Ref: **21744**

### Wind Assessment Addendum – Communal Open Spaces (Levels 2 and 3)

This letter has been prepared in response to the Department of Planning, Housing and Infrastructure (DPHI) and City of Sydney (CoS) requests for further advice regarding pedestrian wind conditions associated with the proposed development.

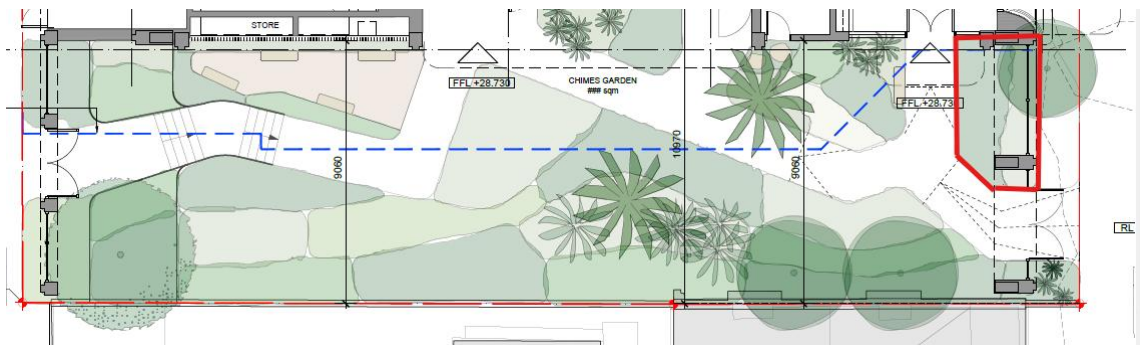
- (a) Locations 1 and 16 should both achieve the 'standing' comfort criteria ( $<6\text{m/s}$ ), which is more appropriate for the 2 main entrances where pedestrians may linger, as per the description in Table 2 of the submitted Pedestrian Wind Assessment.
- (b) All locations of the podium terraces must achieve the 'sitting' comfort criteria ( $<4\text{m/s}$ ). This would require locations 18, 21 and 23 to improve from 'walking', and locations 17, 19 and 20 to improve from 'standing'. The 'sitting' criteria is more appropriate, as the design of all these locations intend for people to sit, but criteria suitable for 'long duration seating areas and other amenities' should be achieved. The commentary that the podium terrace is suitable for 'general pedestrian circulation' is unreasonable. Mitigation measures must be provided and appropriately integrated into the design.

On the ground plane, conditions at the main entrance to the building at Location 16 were only marginally in the 'walking' criterion with a measured 5% of the time wind speed of 6.2 m/s. The larger awning over this entrance in the revised scheme, along with nearby trees and landscaping not considered in the wind tunnel testing would be of some benefit to reducing wind speeds at this location and would be expected to get the 5% of the time wind speed below 6 m/s to achieve the 'standing' comfort criteria.

The pedestrian walking rating at Location 1 at the entrance to the Chimes Garden is primarily due to channelling of winds from the north-east through this space. Milder conditions which are protected from this wind direction, more suitable for stationary congregating were measured close-by at Locations 2 and 3 and pedestrians should be able to find milder conditions suitable for pedestrian standing somewhere in the garden for most prevailing wind directions. The inclusion of landscaping and a raised planter with dense planting such as hedges etc in the marked area below is expected to be beneficial to pushing some of this flow up and above head

height which would be expected to provide some improvement to conditions at Location 1 at the entrance to the garden, and would also provide very significant added protection to Location 2 at the side entrance to the tower lobby.

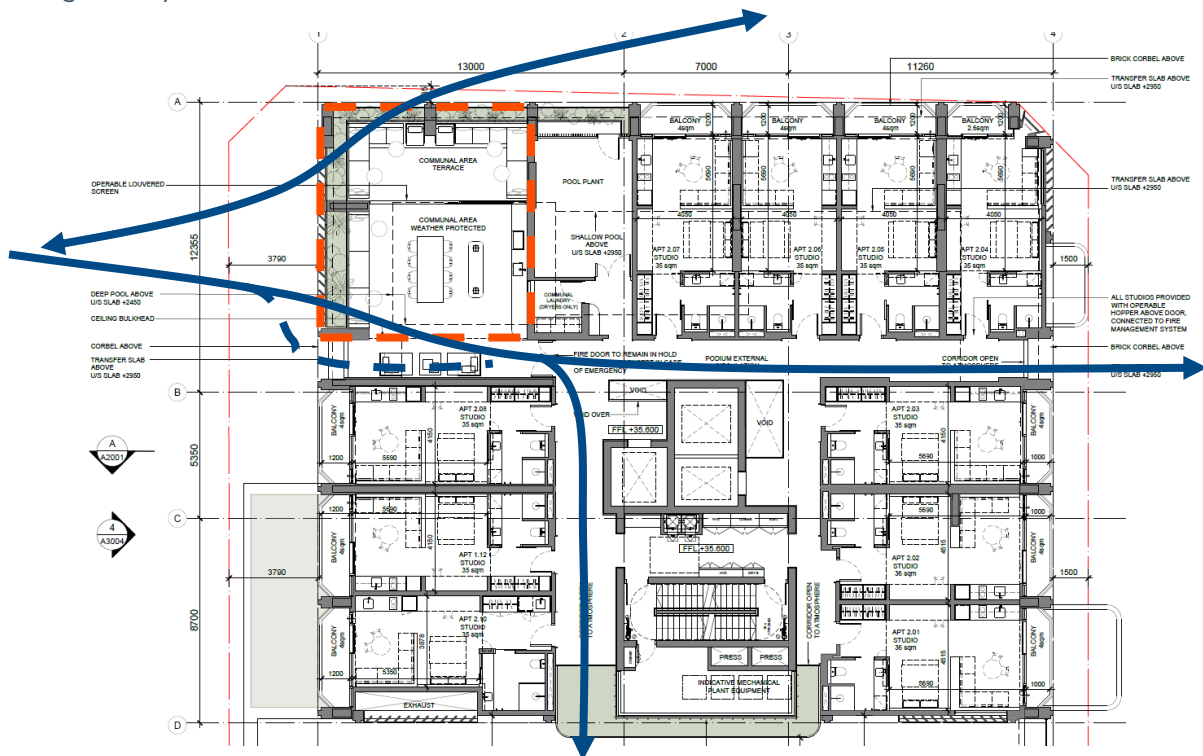
- (a) *wind impacts to the Level 2 communal open space (COS). Where required, mitigation measures must be identified to ensure amenity for residents.*
- (b) *measures which can be implemented to the Level 3 COS area to achieve a consistent Pedestrian Standing rating (or better)*

The Level 2 communal open space sits inset into the north-west corner of the tower platform (shown in Figure 1) and was not considered in CPP's previous assessment for the site. This space consists of a terrace seating space in the north corner, separated by an operable louvred screen to a "weather protected" communal area intended for outdoor style dining directly to the south. Both of these areas have raised planters and structural columns around the outside of these spaces which will provide some baffling to flow through these spaces.

The operable louvred screen would allow the communal area terrace to remain protected on two sides, restricting the flow path for cross-flows through the space to the extreme north-west corner of the space. Moderately windy conditions may exist in this corner for winds from

The weather protected communal dining space is protected to the east by the building and the north by the operable louvred screen, remaining partially open to the west and open to the corridor to the south. Pressure differentials between the east and west façades of the tower, particularly for winds from the west when the west façade is positively pressurised and the east is negatively pressurised, would be expected to push some flow through the weather protected area and through the open corridor from west to east. Similarly, some draughts may be felt through the space for winds from the east as pressure driven flow through the corridor expands into this communal dining space. The vertical solar shading fins along the west edge of the space, along with the 1.4 m solid balustrade behind will provide some reduction to pressure driven flow through the space. Conditions in this area would be expected to be relatively mild, in the pedestrian sitting comfort categories for the majority of the time and generally suitable for use.
